This notice is sent to inform you the Springfield Township Planning Commission will hold a public meeting on Tuesday, May 2, 2023, with a 7:00 P.M. start time to discuss the Land Development Application submitted by **5 Star Venture 1, LP** for a proposed re-development of 900 Mermaid Lane, Wyndmoor, PA 19038.

Reference: 900 East Mermaid Lane
Land Development Application

Re: MCPC #23-0052-001
Plan Name: 900 E Mermaid Lane
(2 lots industrial comprising 3.6 acres)
Situates: Mermaid Lane (E), New St (S)
Springfield Township

PRELIMINARY / FINAL LAND DEVELOPMENT PLAN FOR

RECORD PLAN
TITLE

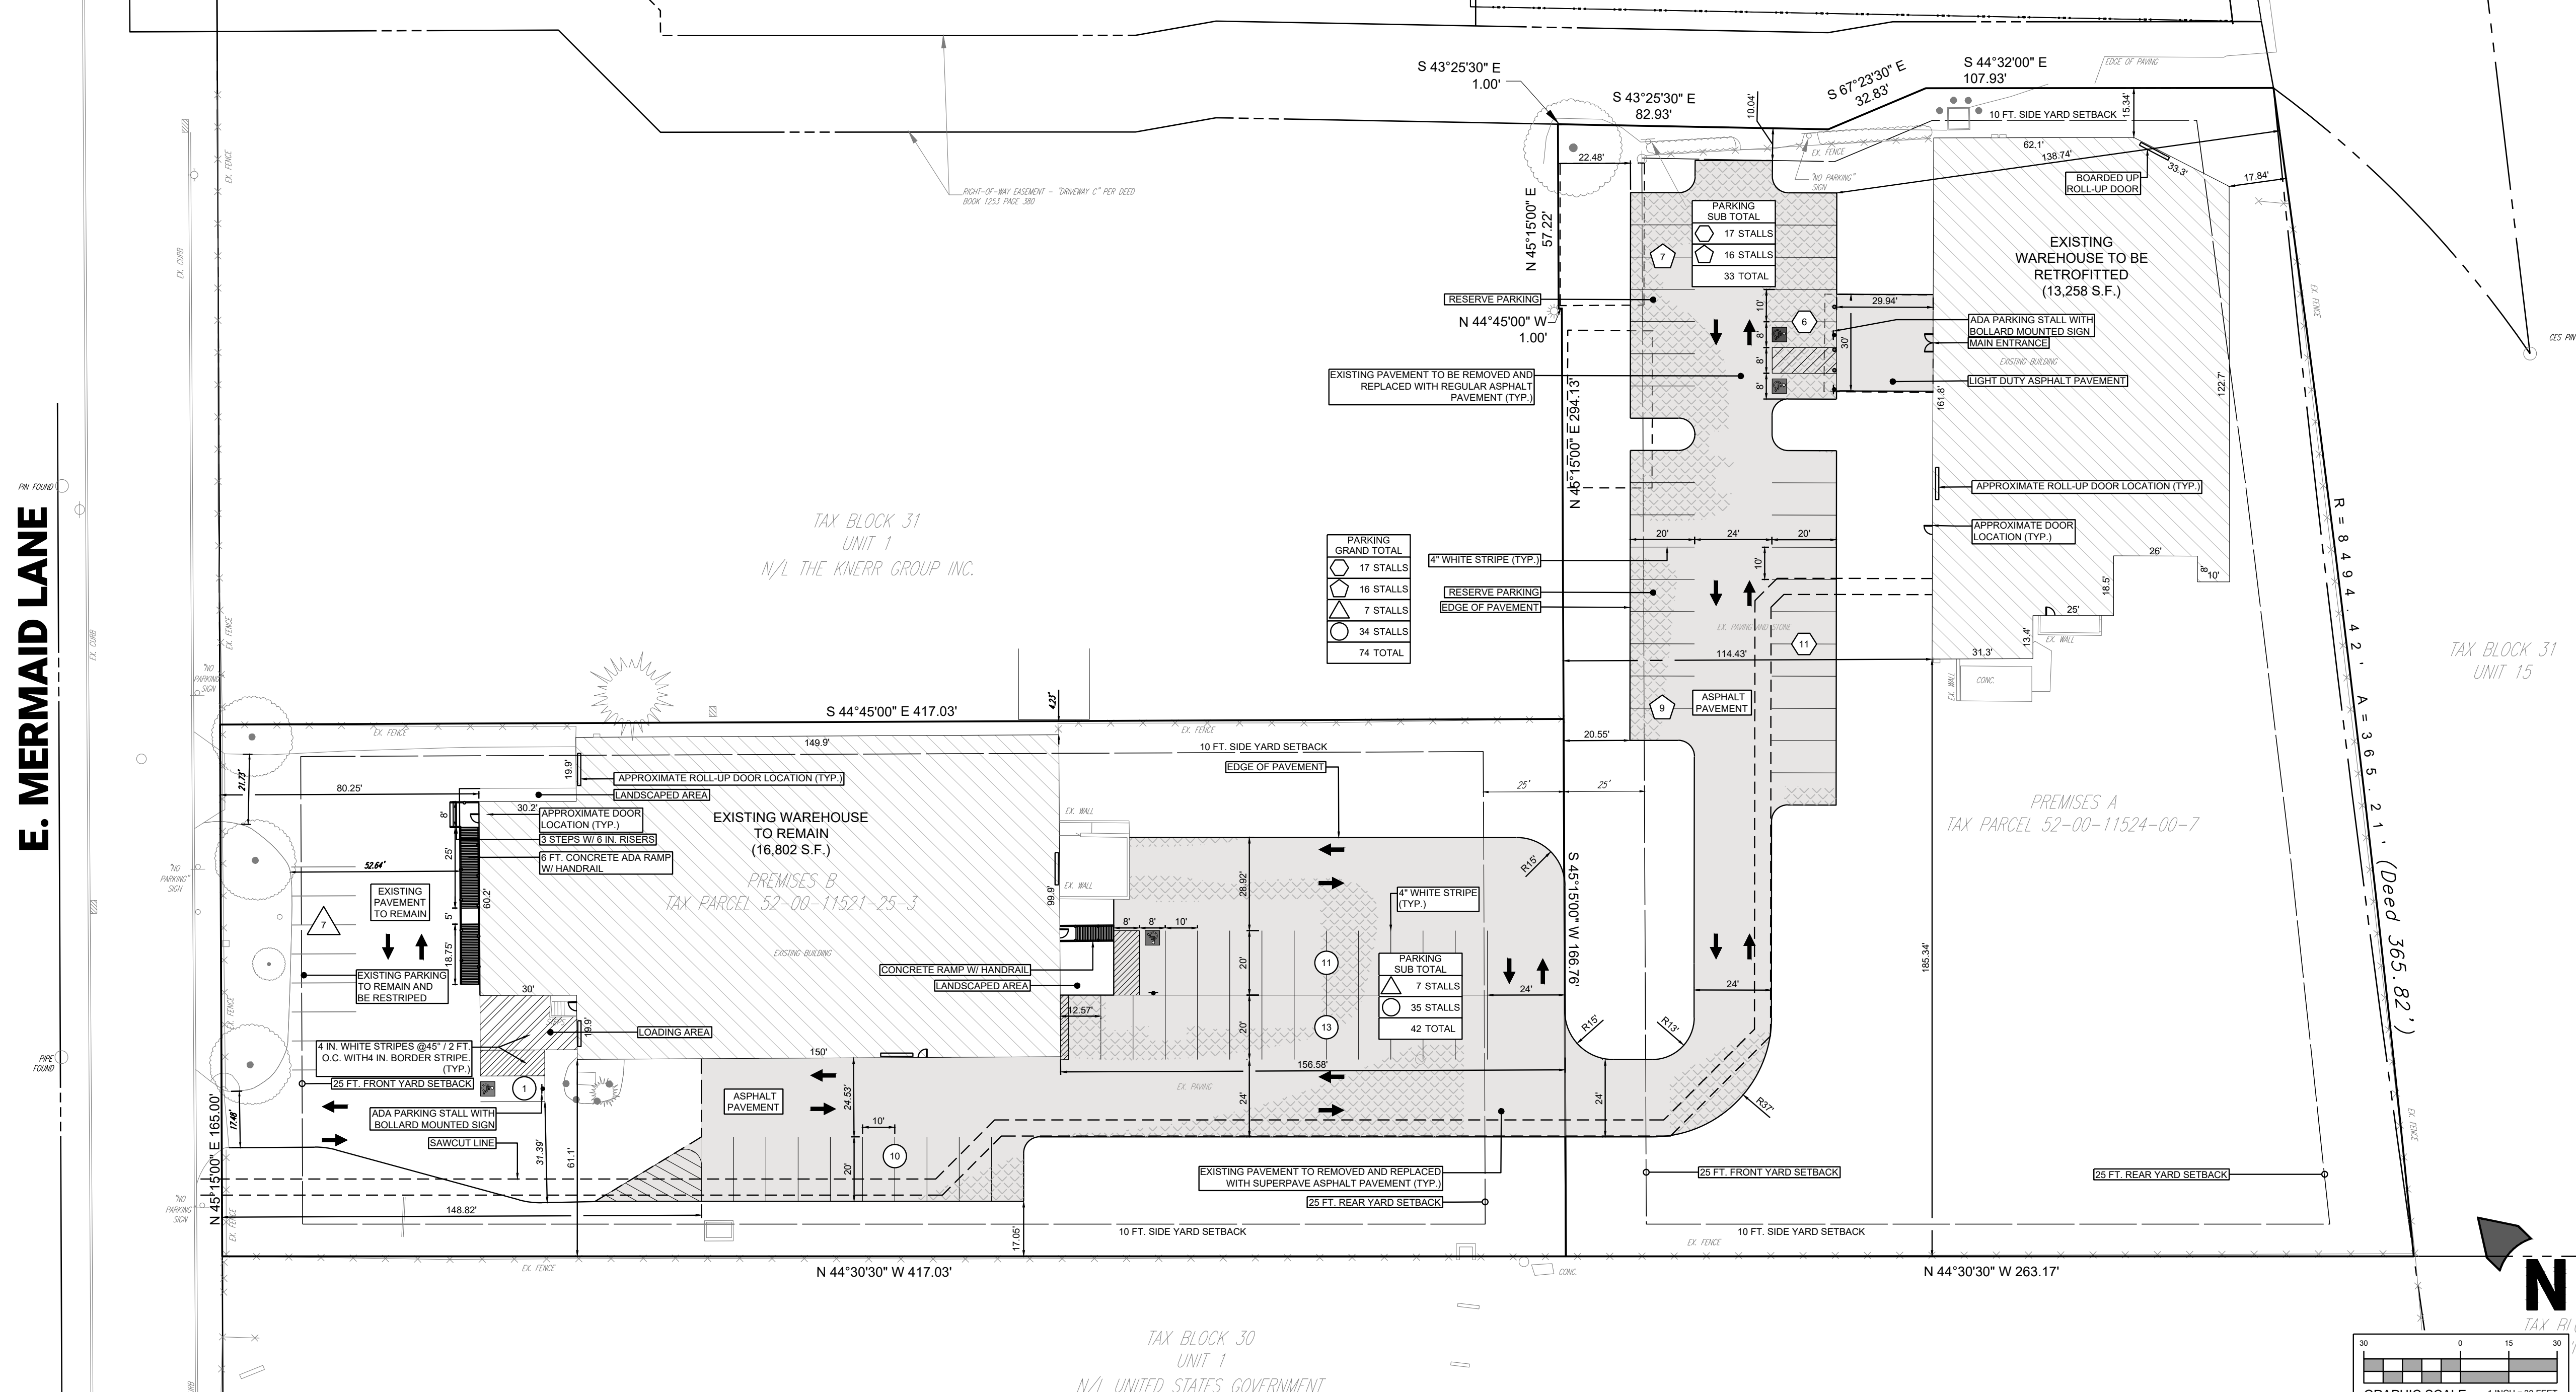
No stormwater management is shown on the plan. Discussions with the township have indicated that a landscaped berm will be constructed along the property line with Mermaid Park, but no such berm is shown on the record plan, utility and grading plan, or erosion and sediment control plan. Mermaid Park is a recipient of Montco 2040 Implementation Grant funding, and we wish to ensure that the park will suffer no visual or stormwater effects as a result of this land development.

- A. Sixteen reserve parking spaces are labelled in the plans, but no extent is shown for the extent of the paving for the reserve parking area. The applicant should clarify whether the reserve parking spaces are intended to be paved at this time. If not, the applicant should show the limits of paving proposed at this time and whether a curb would be constructed along the limits of said paving.

UTILITY & GRADING PLAN

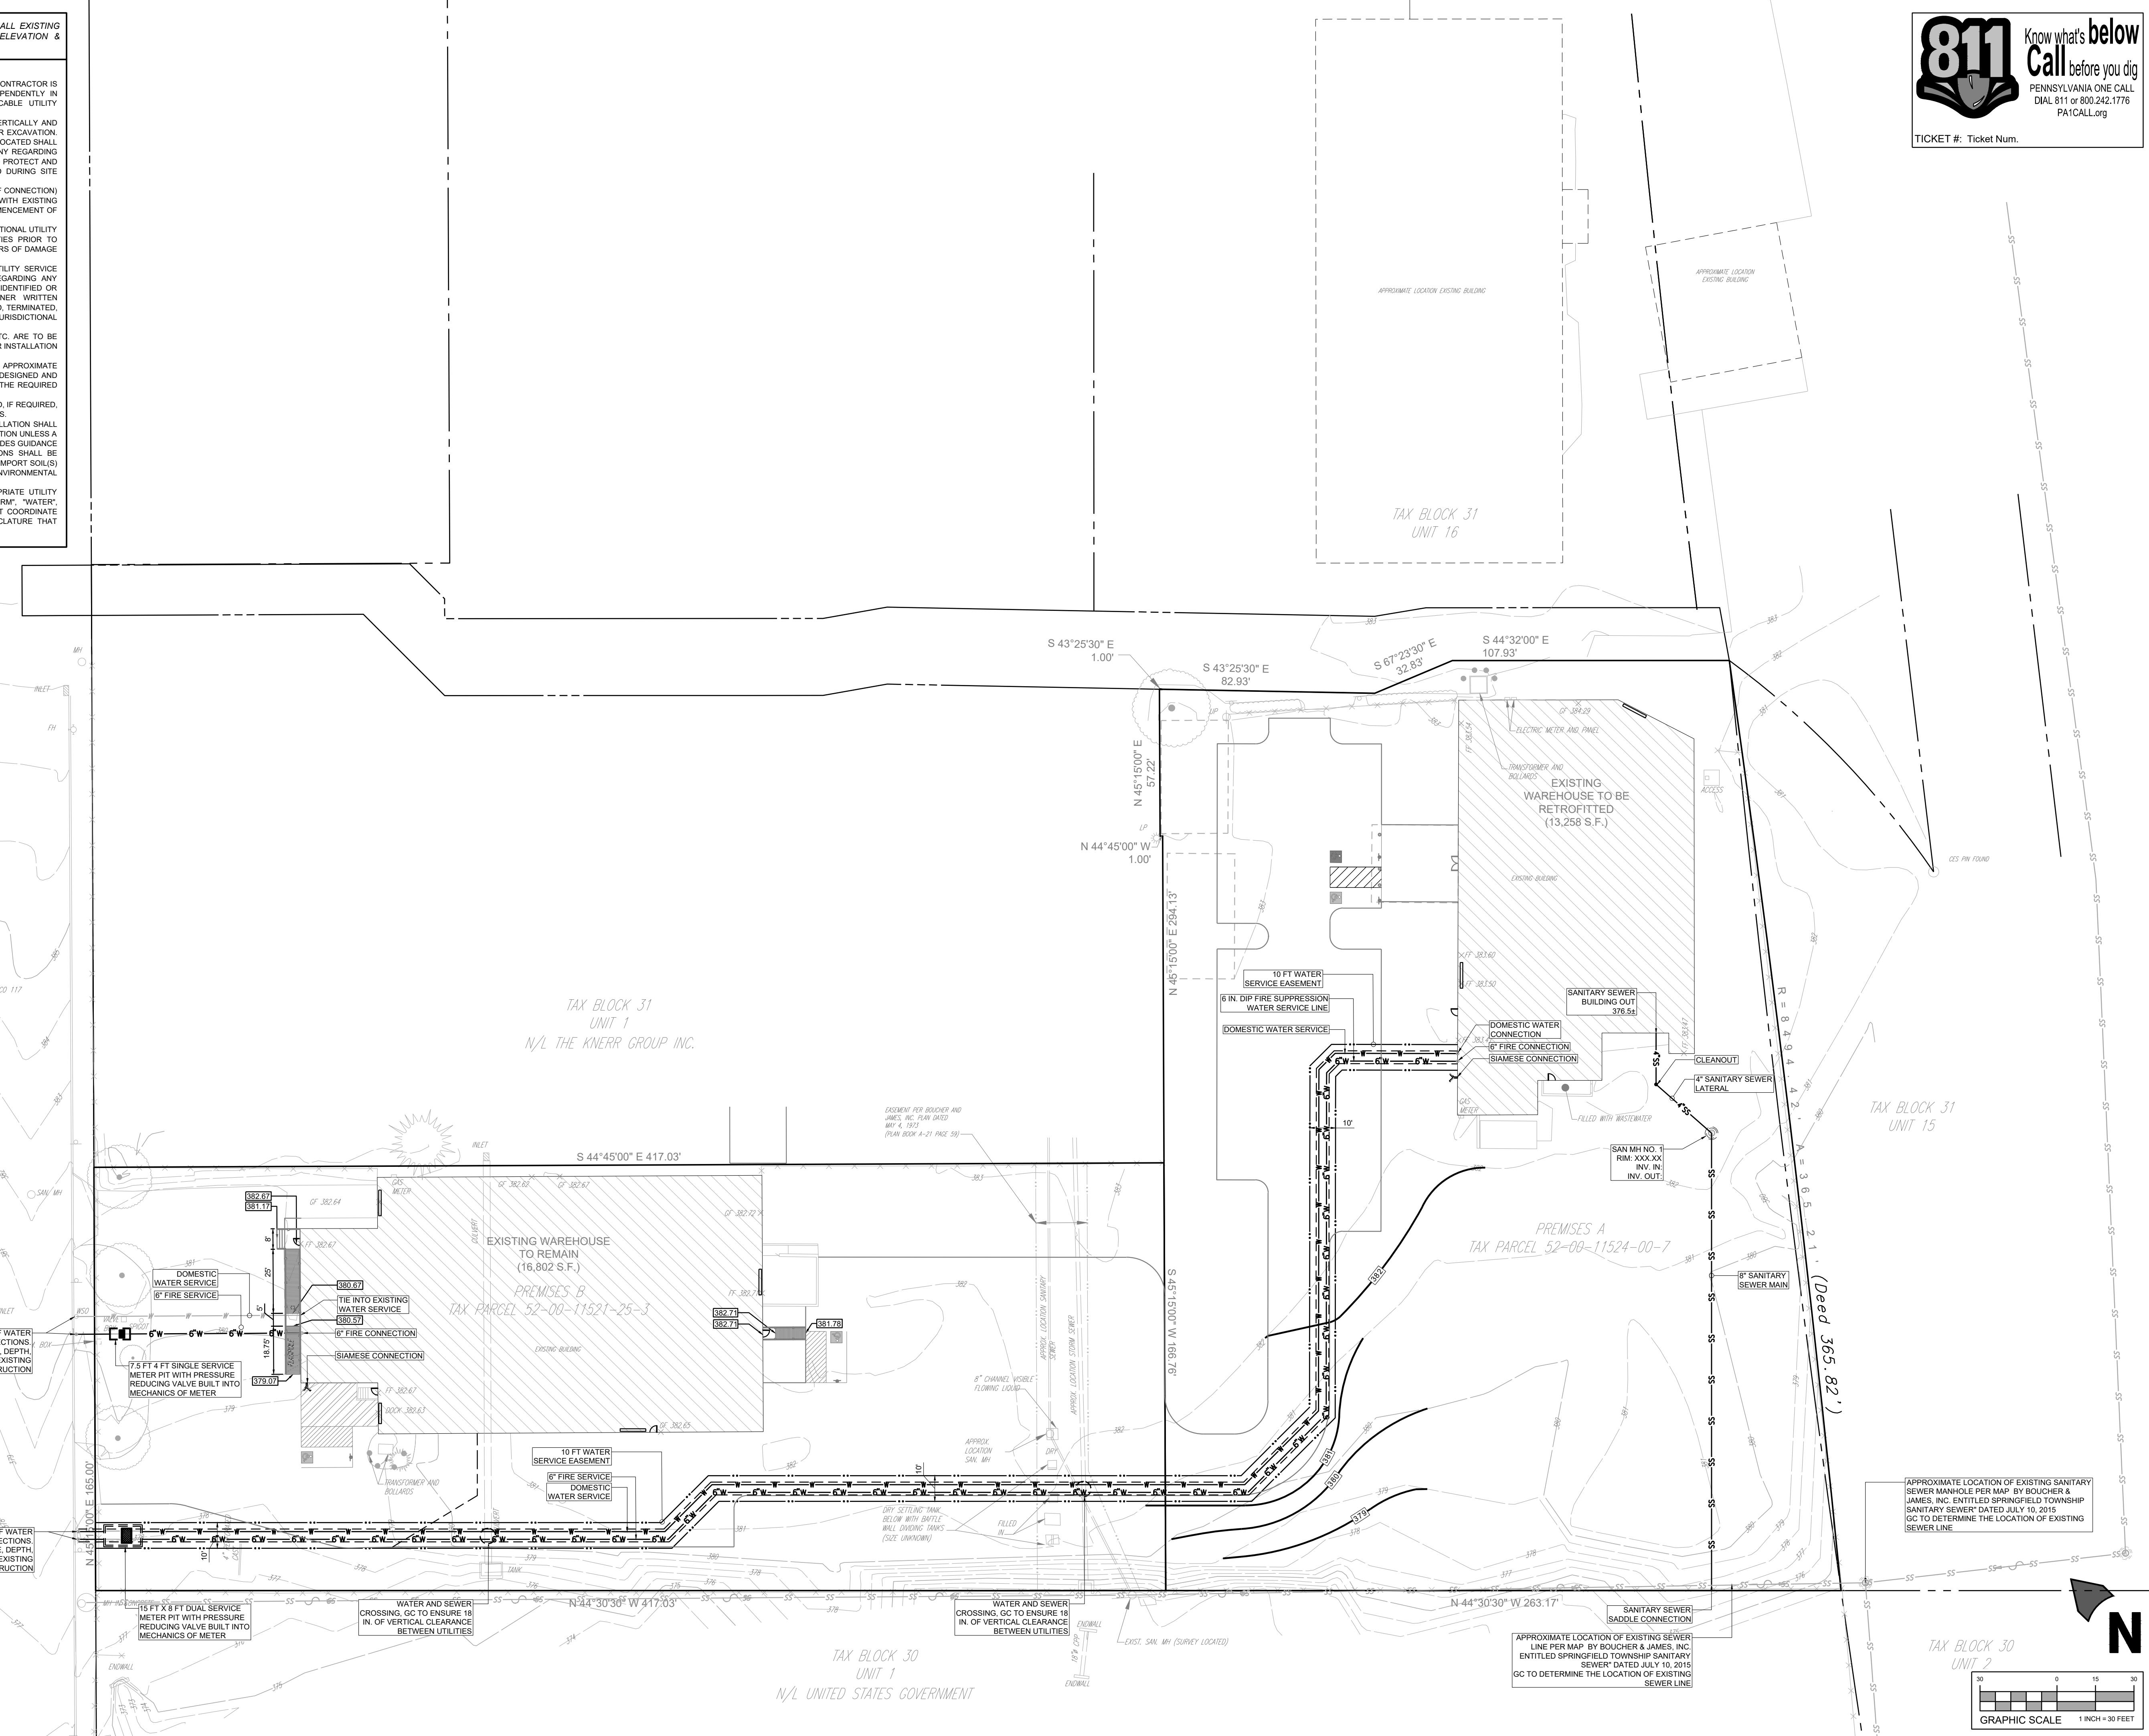
2. Sanitary Sewer – An existing sanitary sewer runs along the southern property boundary. The plan should depict an easement over the sanitary sewer main. Further, the applicant should be in touch with the Bucks County Water and Sewer Authority to determine if any additional tapping fees will be required in conjunction with the application.

LIGHTING PLAN

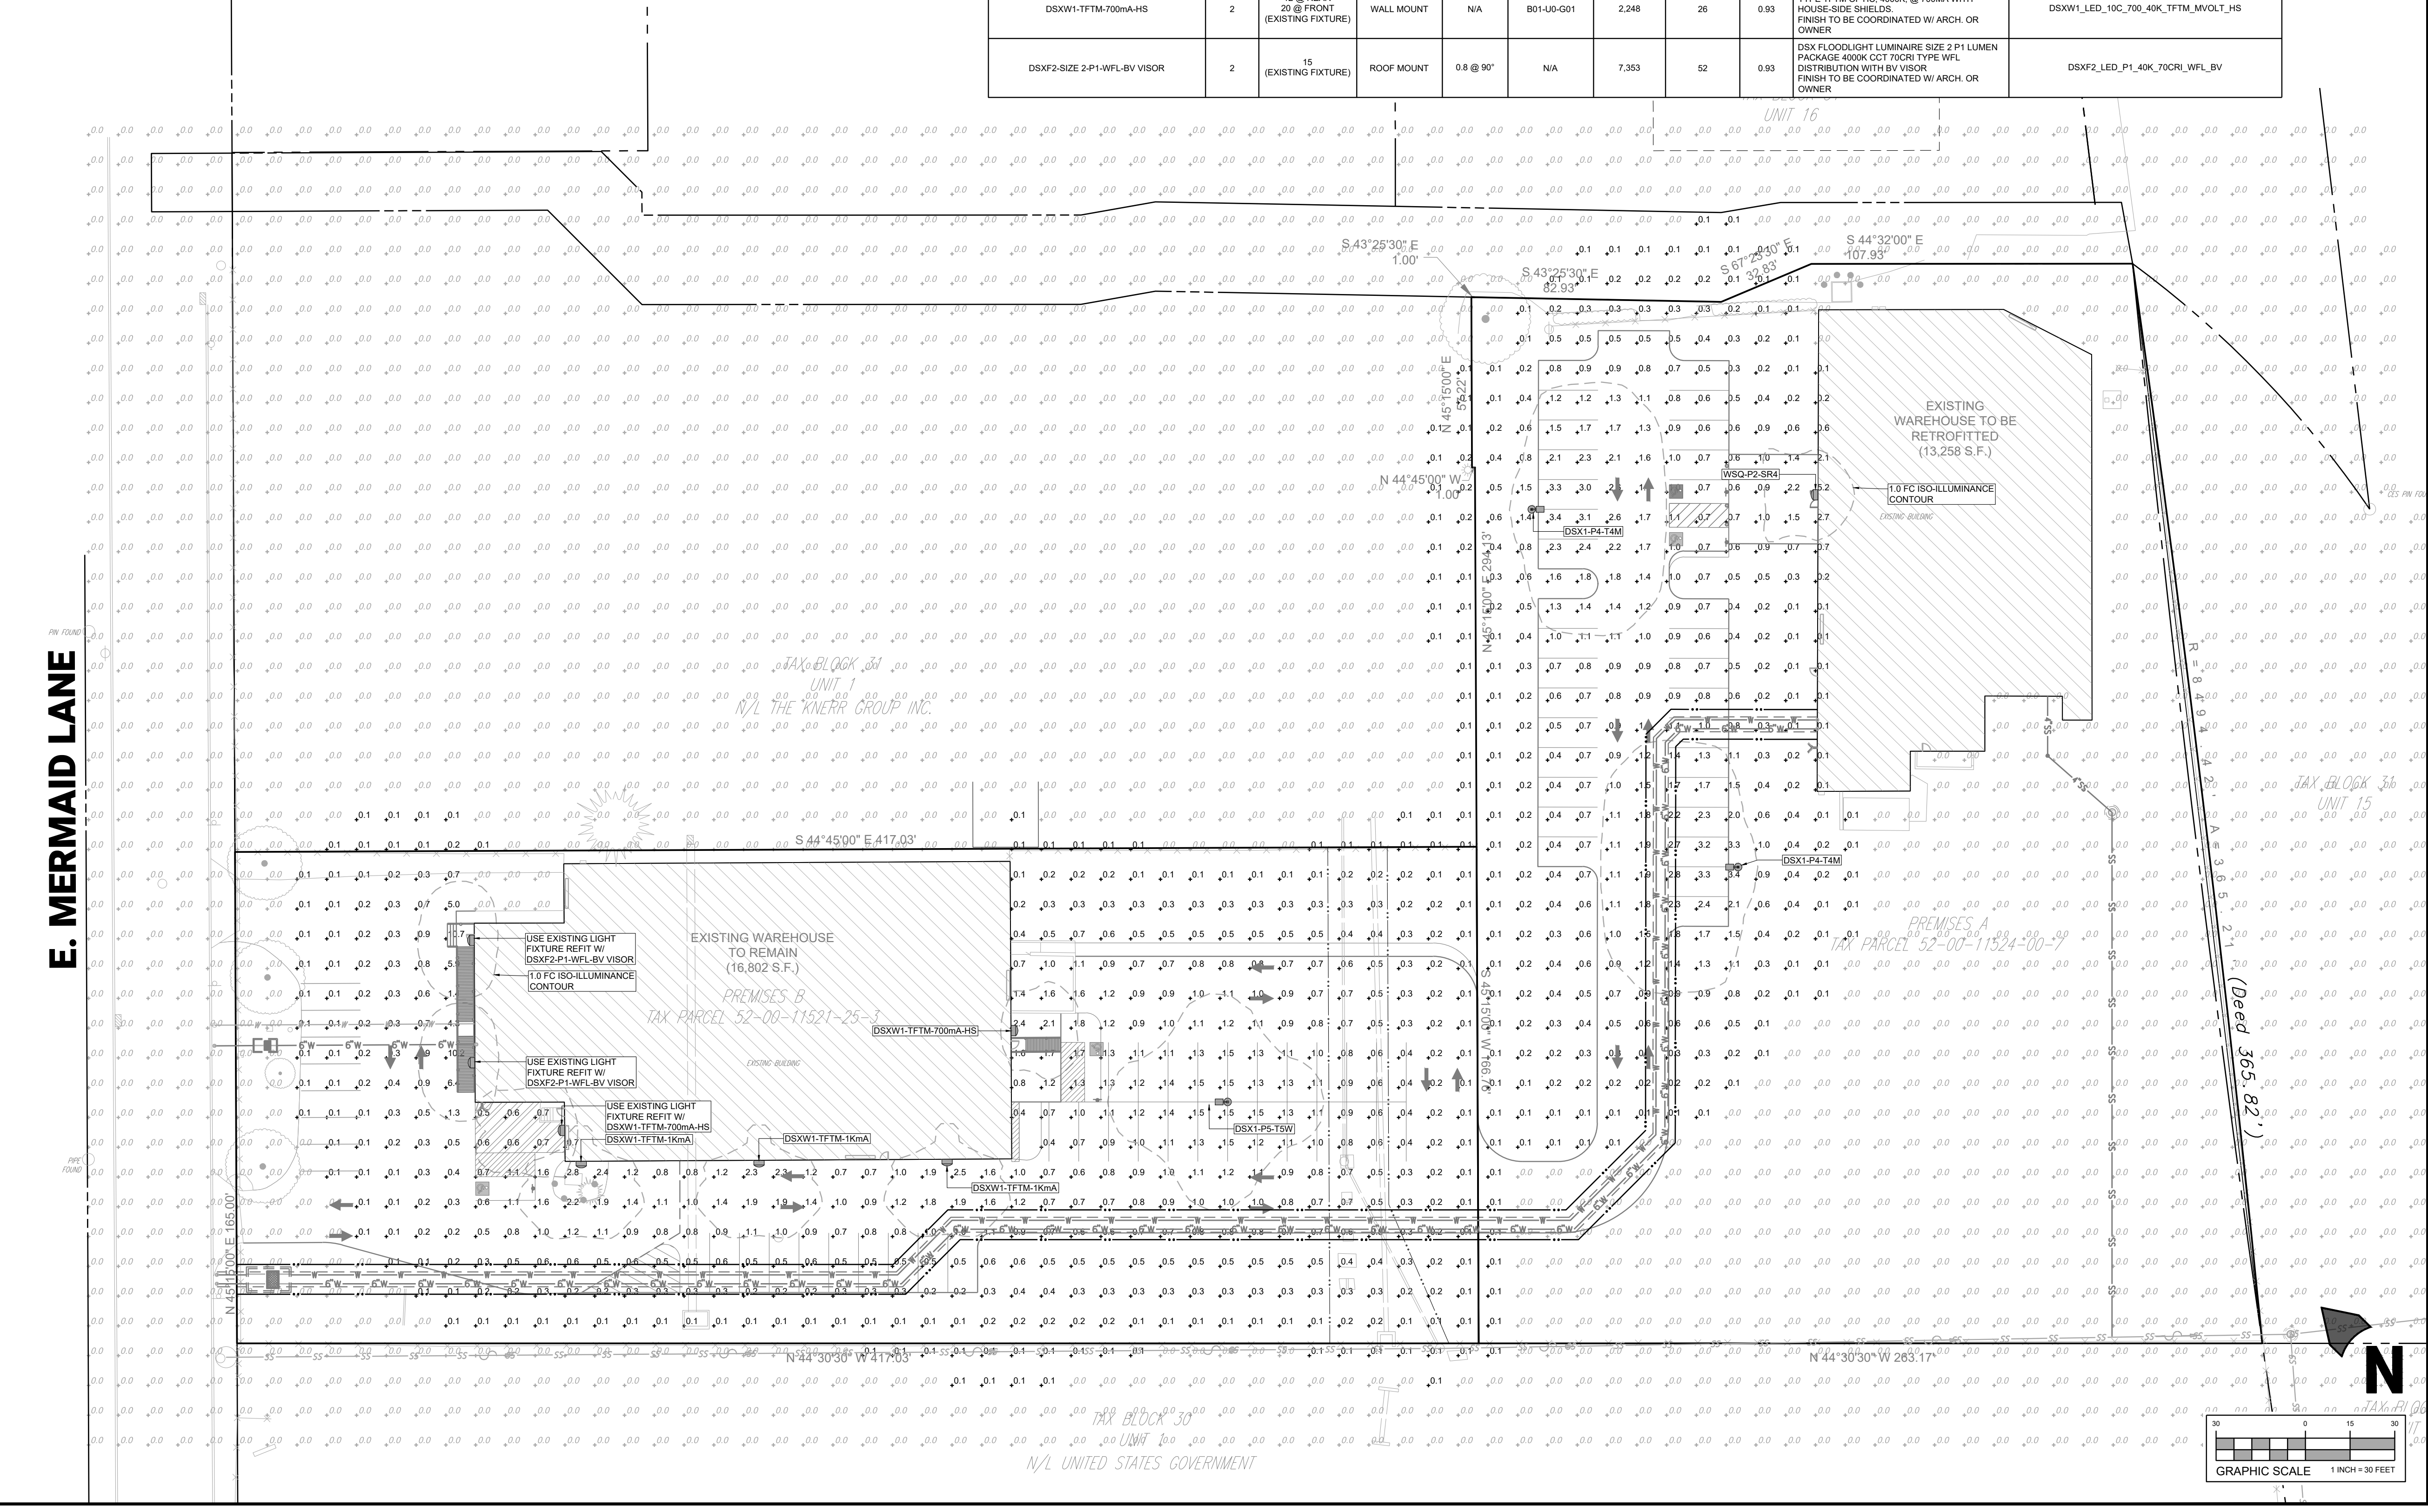
4. Lighting – A lighting plan has been provided. We would ask that the plan contain the following note, “Springfield Township reserves the opportunity to field view the lighting installation after installation. Should undo glare be found to occur impacting adjacent residential properties, additional shielding will be mandated.”
